**Notice of Allowability**

Application No.	Applicant(s)	
10/059,176	HAYASHI, HIROKAZU	
Examiner	Art Unit	
Akash Saxena	2128

**Examiner's Amendment**

**Proposed Examiner's Amendment**

Fig.9

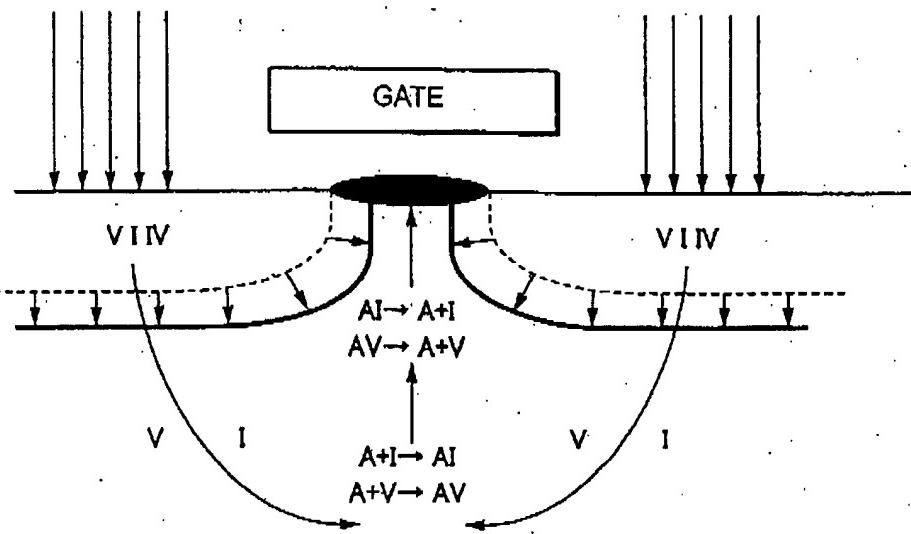
11. **Please replace Drawings starting from Fig.9 to Fig.14 (Drawings pages 5-9, attached as part of the fax with this office action), which indicates Fig.9 to Fig.14 are PRIOR ART.**

Examiner Saxena,  
Enclosed are five (5) drawing Replacement Sheets, wherein Figs. 9-14 have been denoted as "Prior Art", and Fig. 10 has been renumbered separately as Figs. 10A-10C, as requested. Also enclosed is a Proposed Examiner's Amendment, to make the specification consistent with the correction to Fig. 10. If you need any further assistance, please let me know.

**Fig. 10A  
PRIOR ART**

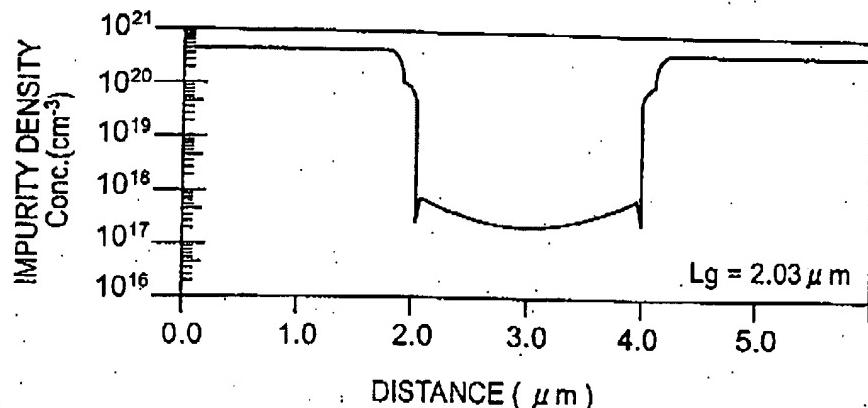
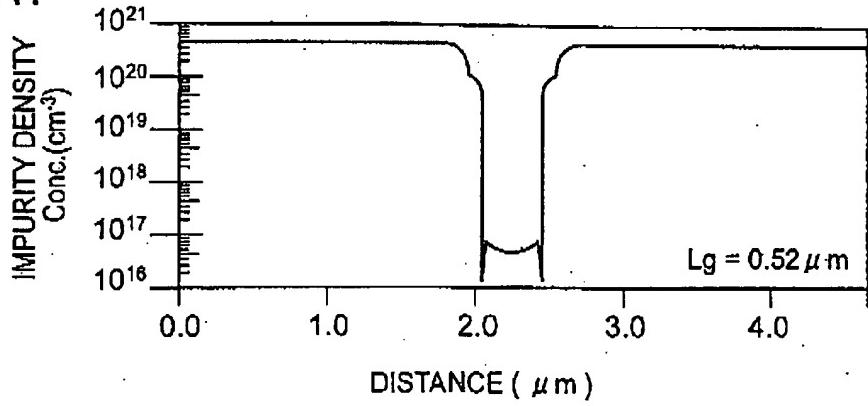
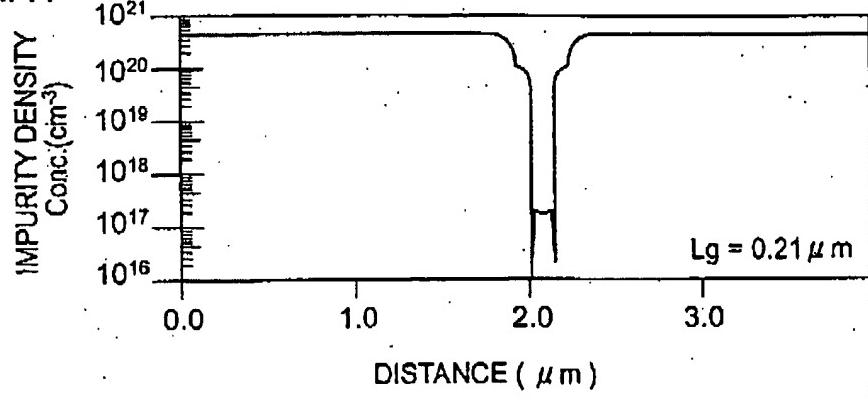
9. **Please replace the paragraph beginning on page 2, line 4 with the following amended paragraph:**

*FIGS. 10A-10C respectively show a relation between a distance of a channel direction Distance, and an impurity density Conc. in a case in which a gate length is set to 2.03  $\mu\text{m}$ , 0.52  $\mu\text{m}$ , and 0.21  $\mu\text{m}$ . In the drawing, a portion having a low impurity density corresponds to a channel, and a rise of the impurity density by impurity pileup is seen in portions corresponding to the drain and source on opposite sides of the channel.*

10. **Please replace the paragraph beginning on page 9, line 22 with the following amended paragraph:**

*FIG. 10A-10C show characteristic curves of a relation between a channel longitudinal direction distance and an impurity density for different respective gate lengths.*

***Please replace the paragraph beginning on page 2, line 4, with the following amended paragraph:***

FIGS. 10A-10C respectively show FIG. 10 shows a relation between a distance of a channel direction Distance, and an impurity density Conc. in a case in which a gate length is set to 2.03  $\mu\text{m}$ , 0.52  $\mu\text{m}$ , and 0.21  $\mu\text{m}$ . In the drawing, a portion having a low impurity density corresponds to a channel, and a rise of the impurity density by impurity pileup is seen in portions corresponding to the drain and source on opposite sides of the channel.

***Please replace the paragraph beginning on page 9, line 22, with the following amended paragraph:***

FIGS. 10A-10C show FIG. 10 shows a characteristic curve curves of a relation between a channel longitudinal direction distance and an impurity density for different respective gate lengths.
